ATTACHMENT 2 TO AEP:NRC:0856 0
PROPOSED CHANGES TO THE
DONALD C. COOK NUCLEAR PLANT
UNIT NOS. 1 AND 2
TECHNICAL SPECIFICATIONS

CHLORINE DETECTION SYSTEM

3/4.7.5 CONTROL ROOM EMERGENCY VENTILATION SYSTEM

FIGURE 1: CONTROL ROOM VENTILATION SYSTEM

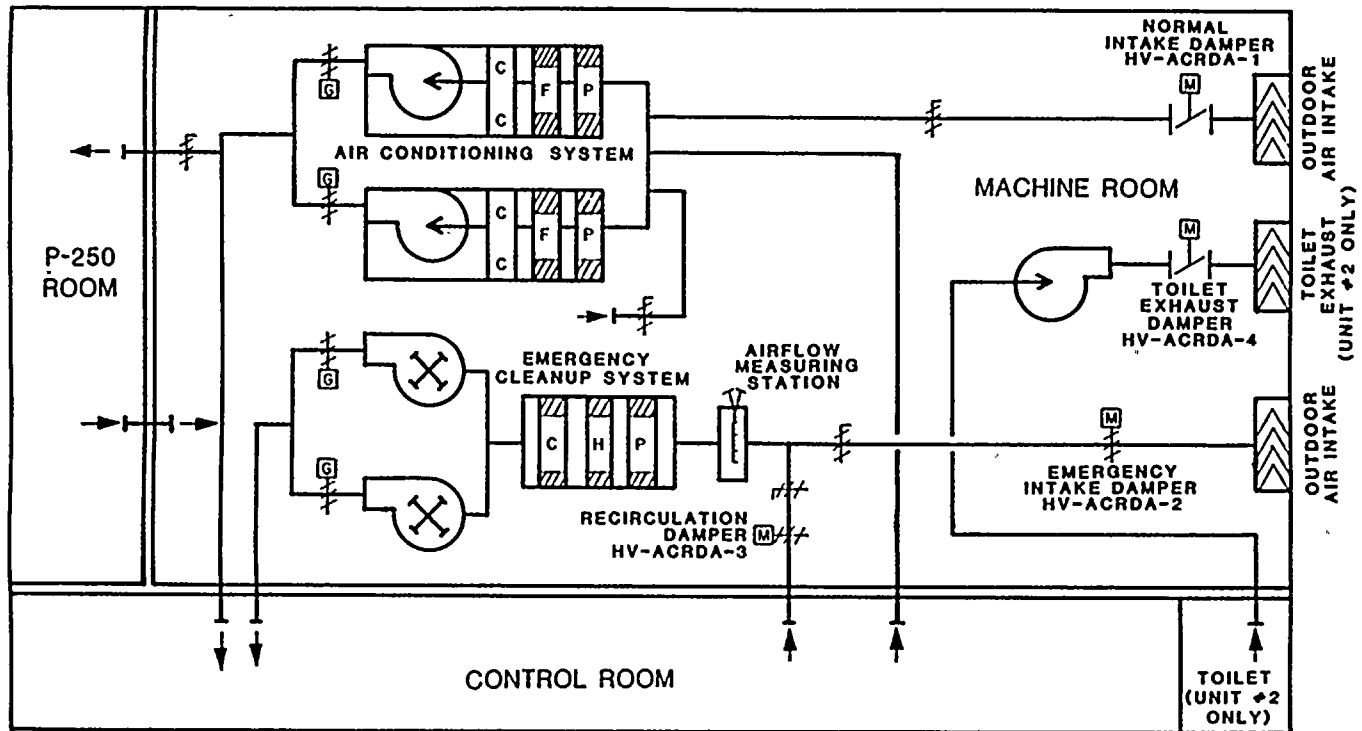
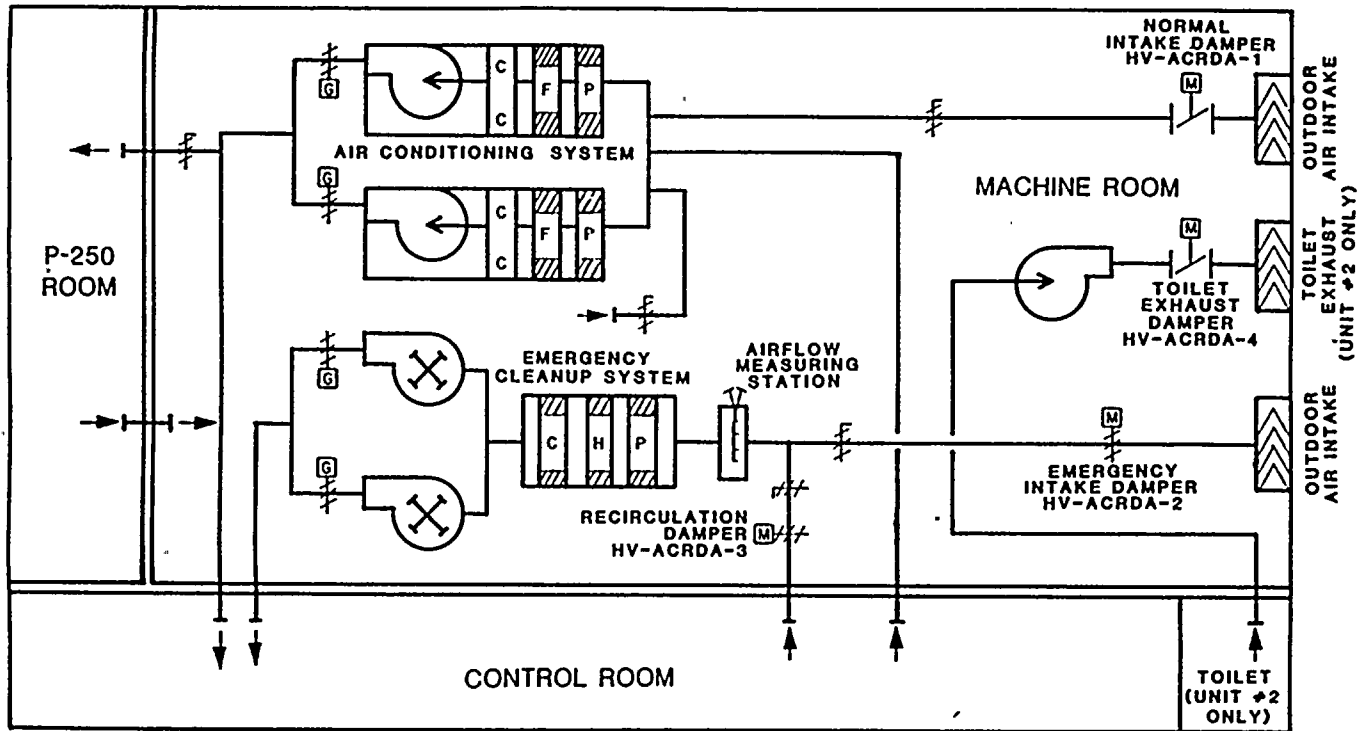
Figure 1, and its accompanying Table 1, provide a graphic representation of the control room ventilation system under normal, radiological, and toxic gas conditions.

Figure 1, and its accompanying Table 1, provide a graphic representation of the control room ventilation system under normal, radiological, and toxic gas conditions.

FIGURE 2: CONTROL ROOM BETA SKIN AND GAMMA BODY DOSE

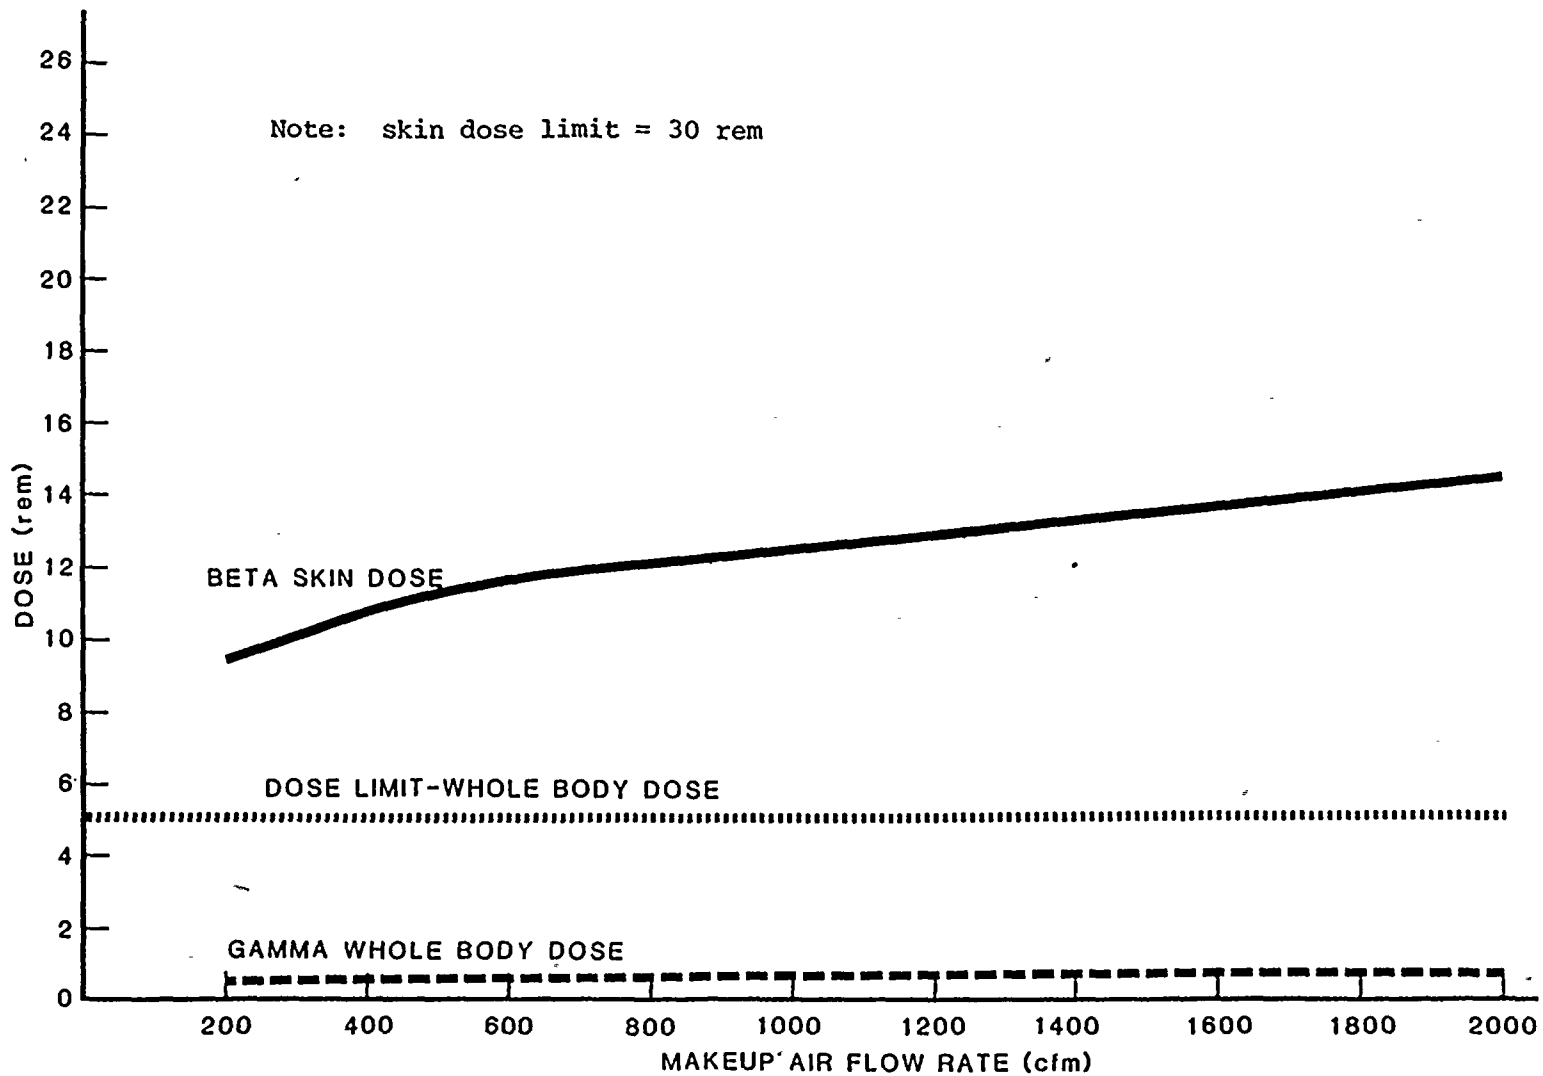
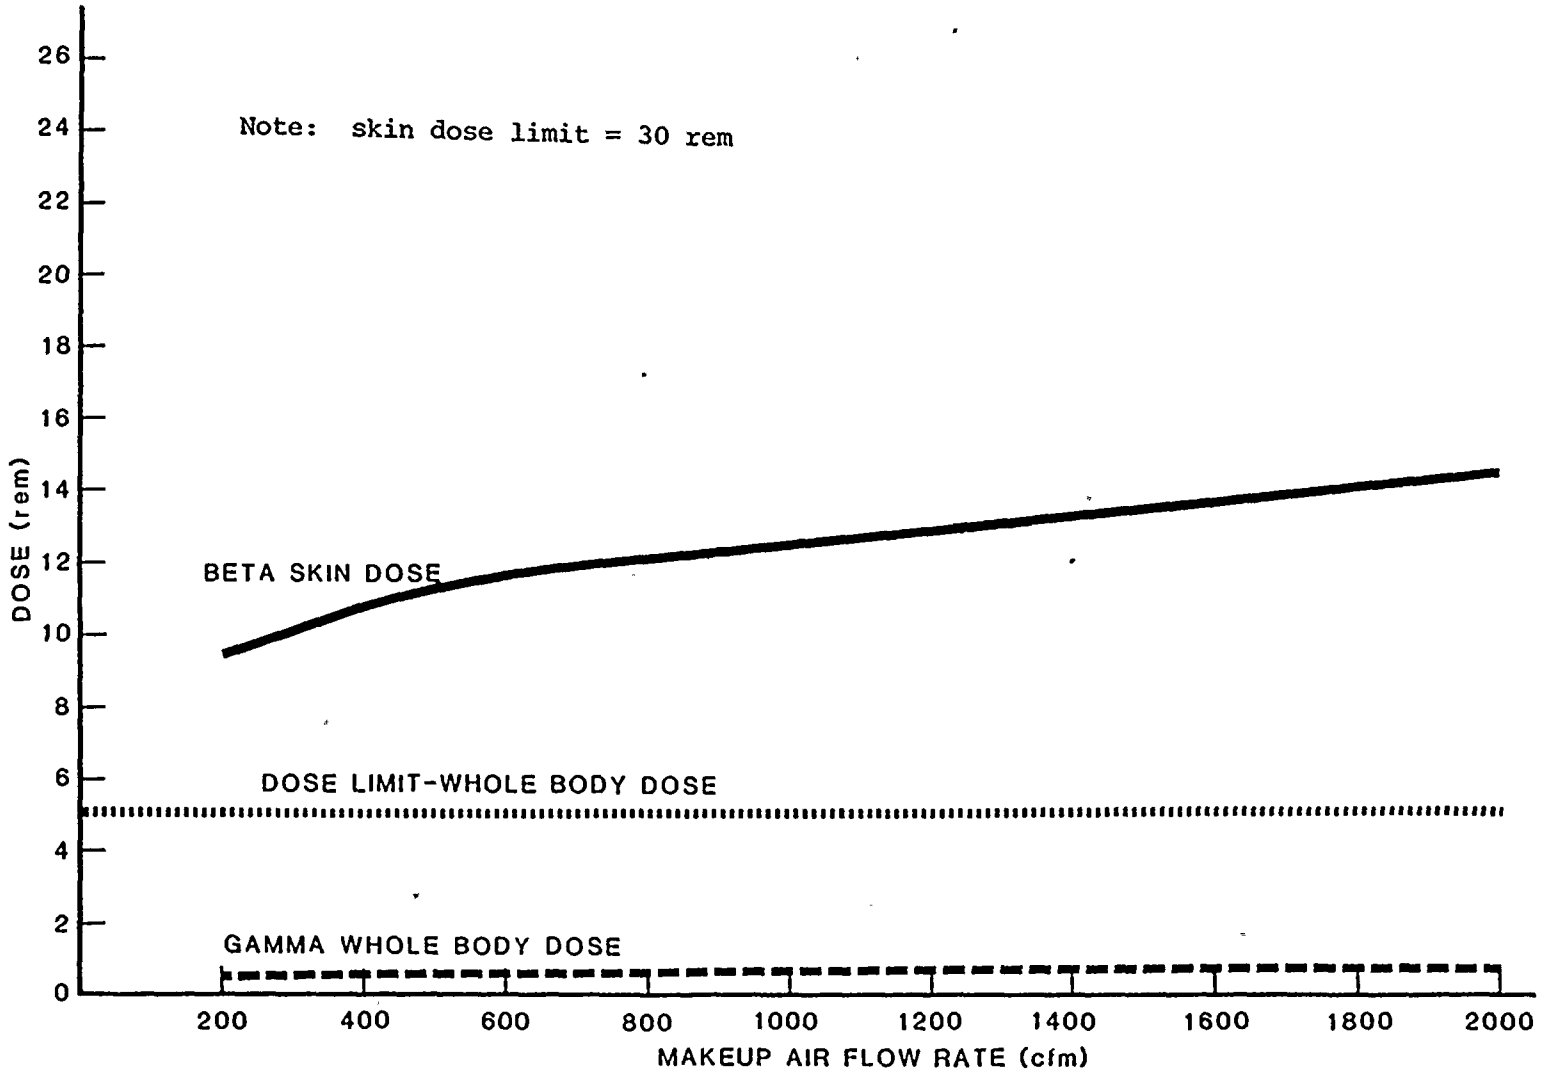
To use the whole body and skin dose curves, the total makeup air flow rate is obtained by summing the filtered and unfiltered values obtained as described above, and verifying that the 30-day dose resulting from this total is below the limits shown. For the thyroid dose, a point on Figure 3 is found which corresponds to the appropriate filtered and unfiltered leakage combination. The 30-day dose associated with this point must be below the 30 rem thyroid dose limit.

To use the whole-body and skin dose curves, the total makeup air flow rate is obtained by summing the filtered and unfiltered values obtained as described above, and verifying that the 30-day dose resulting from this total is below the limits shown. For the thyroid dose, a point on Figure 3 is found which corresponds to the appropriate filtered and unfiltered in-leakage combination. The 30-day dose associated with this point must be below the 30 rem thyroid dose limit.
